WOODBERRY FOREST SUBDIVISION, **UNIT ONE, PHASE TWO**

APPLICATION NUMBER Holdover DATE February 1, 2007
APPLICANT Woodberry Forest Subdivision, Unit One, Phase Two
REQUEST Subdivision

WOODBERRY FOREST SUBDIVISION, UNIT ONE, PHASE TWO

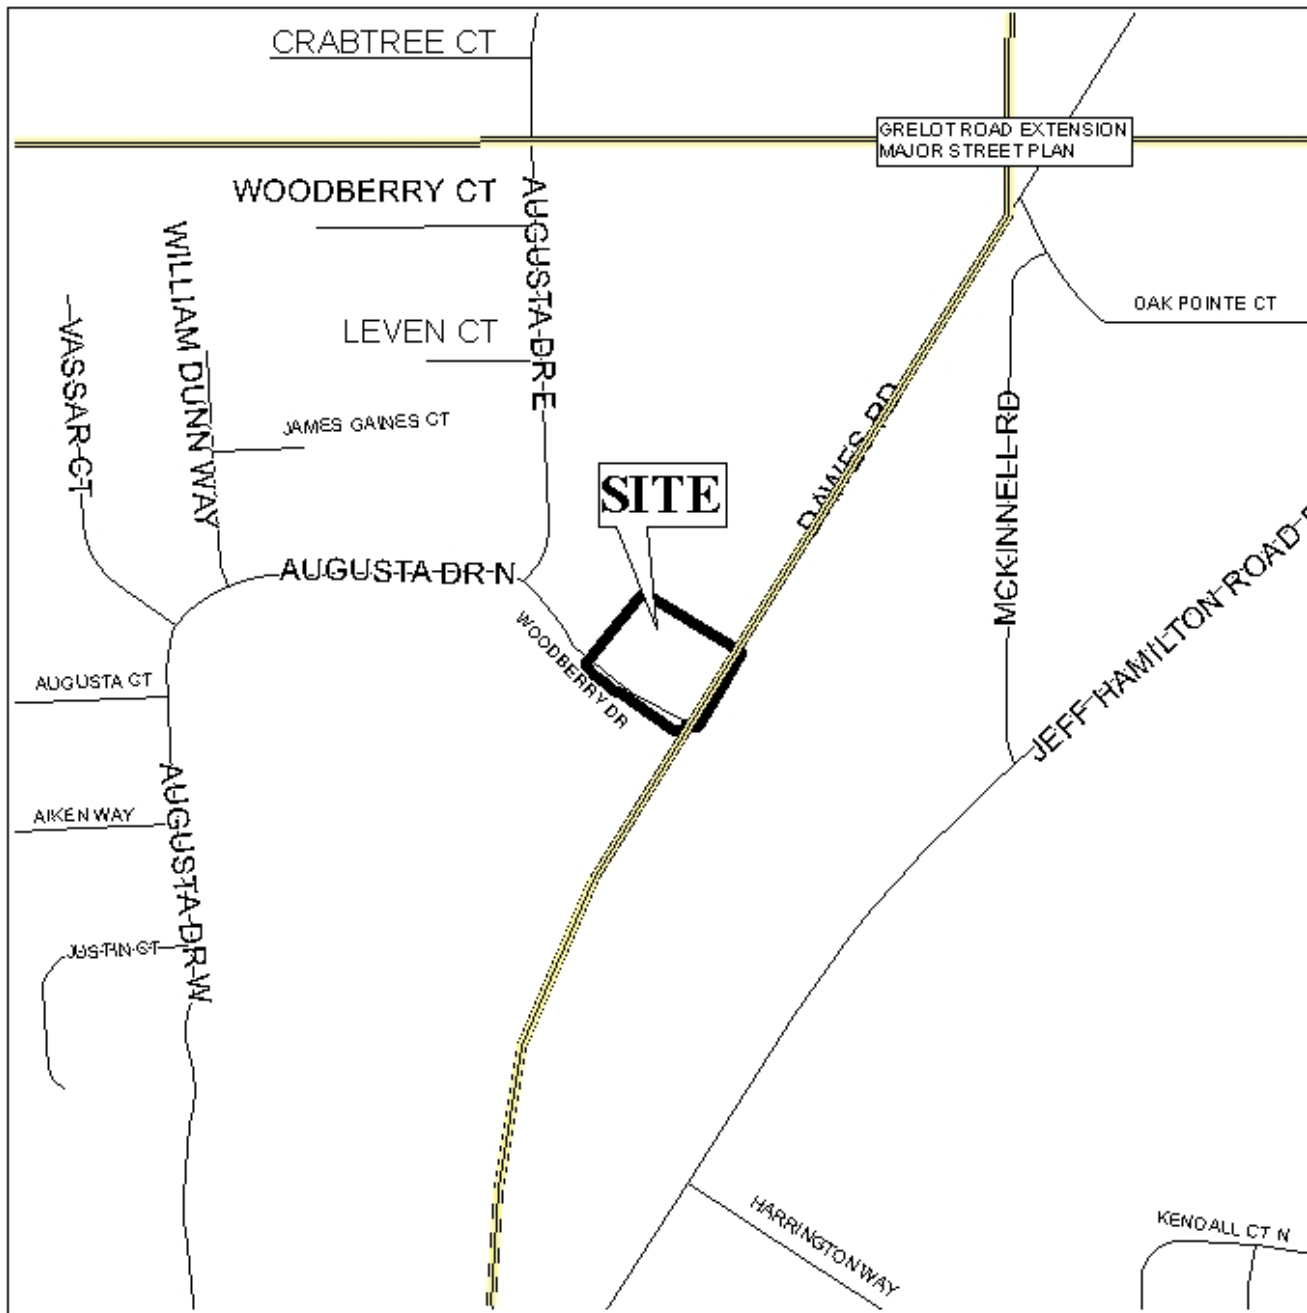
The purpose of this application is to create a two-lot subdivision from two metes and bounds parcels and Common Areas from an existing approved subdivision. The preliminary subdivision is submitted as a 2-lot subdivision with an area illustrated as "Future Development". The applicant should illustrate the inclusion of the "Future Development" area as Lot 3 (37,500± sq.ft.) since the square footage is significantly less than the typical 15-20 acres which the Subdivision Regulations allows to be labeled as "Future Development", and it is currently developed. Therefore, it should not be considered Future Development.

Dawes Road is a proposed major street, as illustrated on the Major Street Plan. The preliminary plat indicates Dawes Road has 60-foot right-of-way, however, the Major Street Plan requires that the right-of-way be 100 feet. Therefore, the dedication of right-of-way sufficient to provide 50-feet as measured from the centerline of Dawes Road, should be required.

Because Dawes Road is a proposed major street, access management is a concern. Therefore, access to the "Future Development" area (Lot 3), with frontage on Woodberry Drive and Dawes Road (major street), should be limited. The resubmission of this application should include the area labeled "Future Development" as a lot since the development could impact Dawes Road.

The proposed lot 1 will exceed the depth to width ratio recommended in Section V.D.3. of the Subdivision Regulations, however, a waiver may be appropriate due to the similar shape and size of the adjacent lots.

Based on the preceding, the plat is recommended for Denial for the following reasons: 1) revised plat illustrating the "Future Development" area labeled as Lot 3 was not submitted.

The applicant submitted revised preliminary plat illustrating the "Future Development" area as Lot 3.

With a waiver of Section V.D.3. for Lot 1, the plat is recommended for Tentative Approval, subject to the following conditions: 1) the dedication of sufficient right-of-way to provide 50-feet as measured from the centerline of Dawes Road; 2) placement of a note on the Final Plat stating that Lot 3 is limited to the existing curb-cut onto Dawes Road, Lots 1 and 2 are limited to the one curb-cut each onto Woodberry Drive, with the size, design and location of all curb-cuts to be approved by the Mobile County Engineering Department; 3) dedication of an appropriate radius at the intersection of Dawes Road and Woodberry Drive, to be coordinated with the County Engineering Department; 4) provision of a certification letter from a licensed engineer to the Planning Section of Urban Development, certifying that the stormwater detention and drainage facilities comply with the City of Mobile stormwater and flood control ordinances, prior to the signing and recording of the final plat; and 5) placement of a note on the Final Plat stating that any lots which are developed commercially and adjoin residentially developed property must provide a buffer, in compliance with Section V.A.7. of the Subdivision Regulation.
